18386A2

# Service Manual

Fig. 1

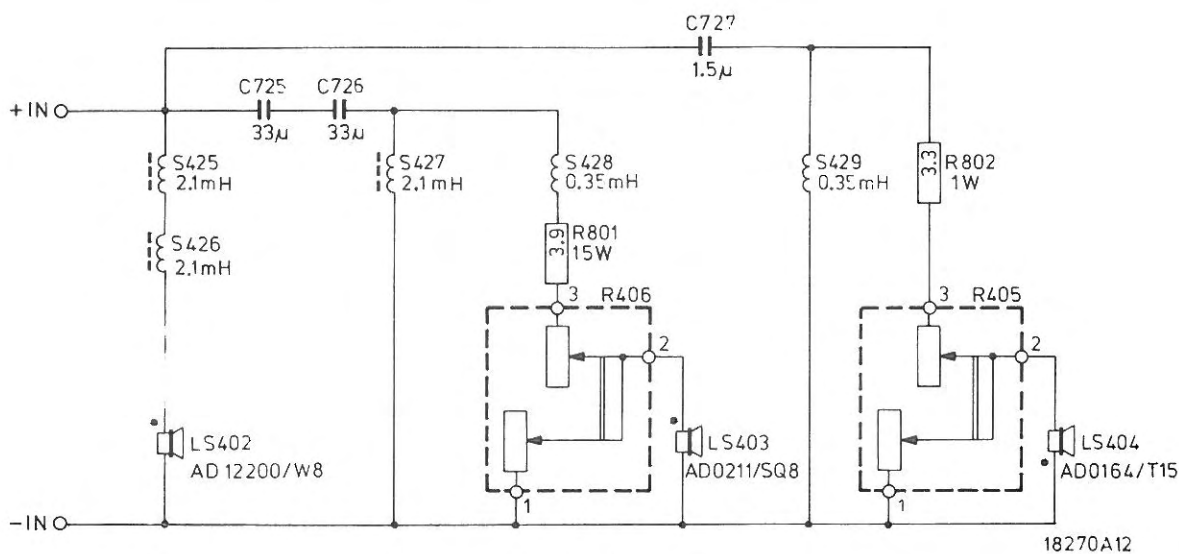
Please adapt the polarity indication for the squawker and the tweeter in the drawings of the Service Manual.  
See Figures 1 and 2.
